UNITED STATES PATENT AND TRADEMARK OFFICE

APPLICATION NO.	FILING DATE	FIRST NAMED INVENTOR	ATTORNEY DOCKET NO.	CONFIRMATION NO.
10/723,317	11/26/2003	William G. Howard	P11515.00	9480
27581	7590	10/26/2006	EXAMINER	
MEDTRONIC, INC. 710 MEDTRONIC PARK MINNEAPOLIS, MN 55432-9924			ALEJANDRO, RAYMOND	
			ART UNIT	PAPER NUMBER

Office Action Summary

FIG. 1

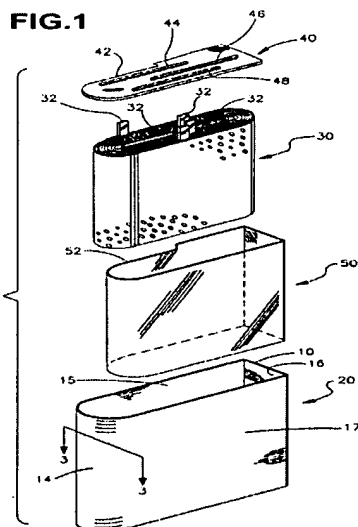
Haas et al disclose a battery or electrochemical cell (TITLE/ ABSTRACT/ COL 1, lines 65-66) comprising a case 20, an electrode assembly 30 and case cover 40 sealing the case (COL 5, lines 26-30). Electrode assembly 30 includes respect tabs 32 (COL 6, line 58-63). The battery also comprises a headspace insulator 70 including a surface area capable of acting as a receiving area (COL 7, lines 7-10 & lines 20-25).

One preferred case cover 60 includes a feedthrough 62 through which feedthrough pin 64 is inserted; the feedthrough pin 64 is conductively insulated from the cover 60 by any suitable material (*either the insulating member or the ferrule*) (COL 7, lines 9-15). It is also disclosed that additional insulation in the form of tubing or a coating around or on the feedthrough pin 64 may also be included to further insure electrical isolation of the feedthrough pin 64 (*either the insulating member or the ferrule*) (COL 7, lines 38-42). *In this case, if the suitable material is considered the insulating member, then the additional insulation may be considered the ferrule, or vice-versa.* Additionally, feedthrough pin 64 is bent to align itself with the desired connector tabs 32 extending from the electrode assembly 30 (COL 7, lines 13-15). *Thus, the feedthrough pin is coupled to an electrode tab.* **Figures 1-2** illustrate the battery embodiment:

There is a connection between one set of the connector tabs 32 and the case 20 (COL 7, lines 2-6). *This represents the bracket coupled to the battery cover and the electrode tab.*

Disclosed is that the headspace insulator 70 is preferably located below the case cover and above the coil insulator 40 (COL 7, lines 20-23). *When these elements are brought together in a mechanical manner so as to assemble the battery, the headspace insulator indirectly couples to, touches or contacts the cover.*

Coil insulator 40 includes a notch 42 to accommodate one of the electrode tabs and slits 44, 46 and 48 to accommodate other connector tabs 32 (COL 6, lines 58-63).

Electrode assembly 30 is also inserted into a case liner 50 (COL 6, lines 64-66).

FIG. 2

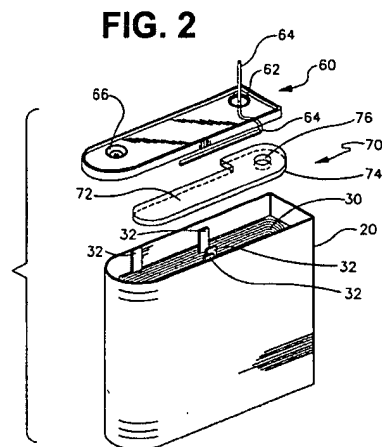
Headspace insulator 70 is a solid, generally parallelepiped shaped unit (See cutaway view of thereof below). Cut part and respective opposing side of the headspace insulator 70 is also another side thereof.

Cut part and respective opposing side of the headspace insulator 70 is also another side thereof (See sub-cutaway view thereof below).

Headspace insulator 70 includes a raised surface 72 (COL 7, lines 23-25). **Examiner's note:** *as to the limitation "adapted to" does not distinguish over prior art because the recitation that an element/feature/member is "adapted to" perform a function is not a positive limitation but only requires the ability to so perform. See MPEP 2111.04*

A well 76 is preferably formed in the raised surface 72 where the feedthrough pin 64 is inserted through the headspace insulator 72; and it is preferably adapted to receive the structure surrounding the feedthrough 62 formed in the cover (COL 7, lines 25-35). Well 76 has a curved

(circular) portion (See Figure 2 above). **Examiner's note:** *as to the limitation "adapted to" does not distinguish over prior art because the recitation that an element/feature/member is "adapted to" perform a function is not a positive limitation but only requires the ability to so perform. See MPEP 2111.04*

It is noted that when these elements are brought together in a mechanical manner so as to assemble the battery, distal end of feedthrough pin 64 will rest on, or touch or contact or be received in headspace insulator 70.

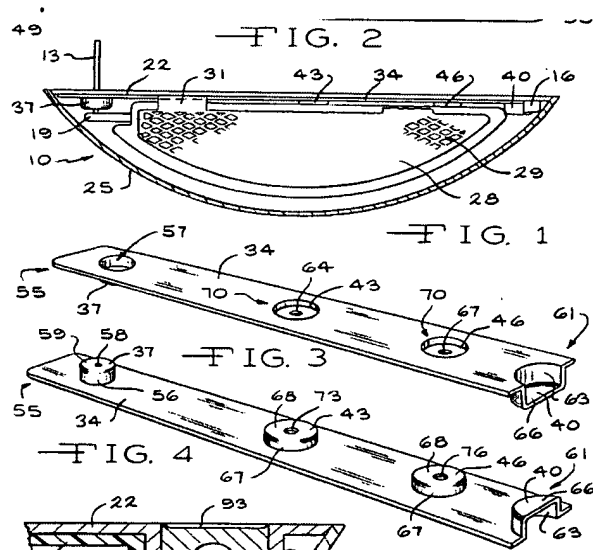
Probst et al disclose an electrochemical cell (ABSTRACT) comprising a battery case 25, lid 22 sealing the battery case 25; respective cathode electrode-connection tab 19 and anode electrode 28-tab connector 31 (*the electrode assembly with tabs*) (COL 3, lines 1-12). It also comprises a header insulator 34 having a first boss 37 comprising a specifically shaped wall

having an open end 57 and further including an opening 58 for receiving the feedthrough pin 13 (COL 3, lines 35-60).

Feedthrough assembly includes the feedthrough pin 13 (COL 3, line 2); terminal ferrule 20 and glass insulator 24 (COL 3, lines 3-8). Feedthrough assembly in the headspace insulator also includes the feedthrough pin 13 (COL 3, line 2); and boss 37 comprising a specifically shaped wall having an open end 57 and further including an opening 58 for receiving the feedthrough pin 13 (COL 3, lines 35-60).

The anode electrode 28 has a tab connector 31 that connects to the underside of the lid 22; by connecting the anode electrode to the lid 22, the electrochemical cell 10 is thereby disposed in the case-negative configuration (COL 3, lines 9-17). *This arrangement constitutes the claimed bracket.*

Head insulator 34 comprises a solid, generally parallelepiped shaped unit. See feature 34 in the Figures 3-4.
